SJ10-03

<u>SERVICE NOTE</u>

Supersedes: N5000A-03 N5000A-04 N5002A-03 N5002A-04

Agilent SJ10 Optical Board Test System Models: N5000A and N5002A

Fig 1.0

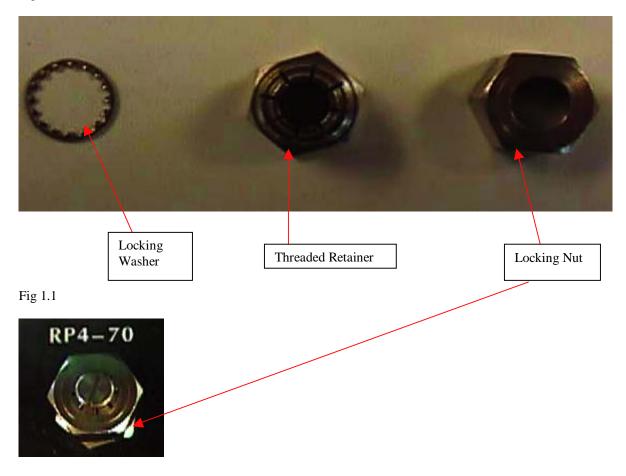
- 1. Remove the lid from the potentiometer box unscrewing the 4 retaining screws with a Phillips screwdriver. Next use a small flat blade screwdriver to remove the pot cabling from the connector block.
- 2. Take a note of the cabling numbers on the connector as you will need them later.
- 3. Using a pair of pinch nose pliers carefully remove the locking nut from the potentiometer see fig 1.1. See parts of potentiometer Fig 1.0 for reference.

Fig 1.3

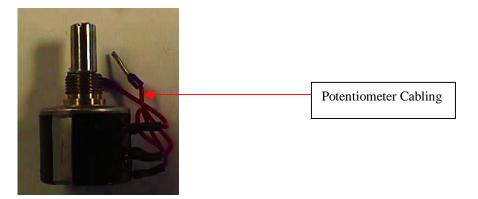
- 1. Refit the new potentiometer into the old space as in Fig 1.2.
- 2. Replace the locking washer on to the assembly.
- 3. Fit the threaded retainer and screw down tightly.
- 4. Screw on the locking nut tight ensuring the pot shaft cannot turn .
- 5. Now rewire the pot cabling to the connector (see fig 1.3)
- 6. Replace the pot box lid and the fixing screws.
